State Air Pollution Control Board & Department of Environmental Quality

**Presentation
By
City of Alexandria**

January 25, 2008

Proposed Two-Stack Permit Is Flawed and Does not Address SAPCB Mandate

Trona Increases PM Emissions

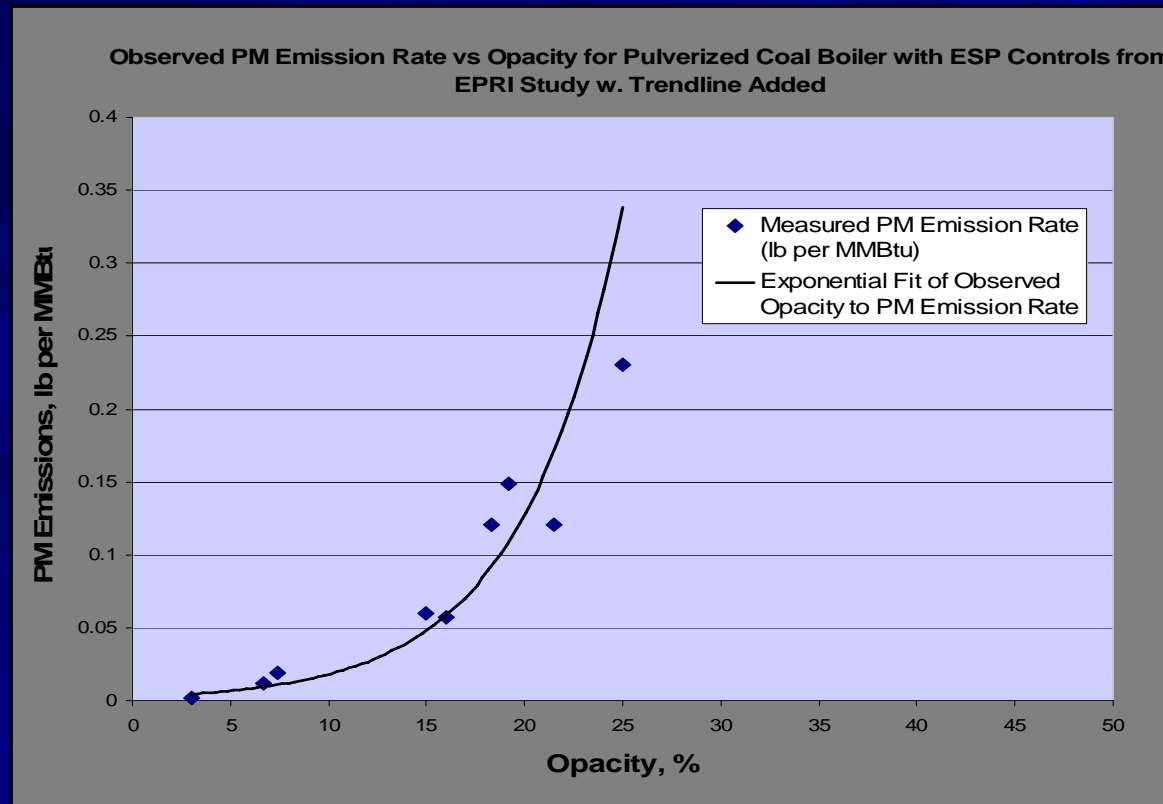
- Mirant opacity data shows increase in opacity with trona injection
- Frequency of episodes of >20% opacity also increases with trona

Boiler #3 showed the least negative impacts of trona on opacity. However, it was the only boiler used for comparing scenarios with and without trona in 2006 stack testing
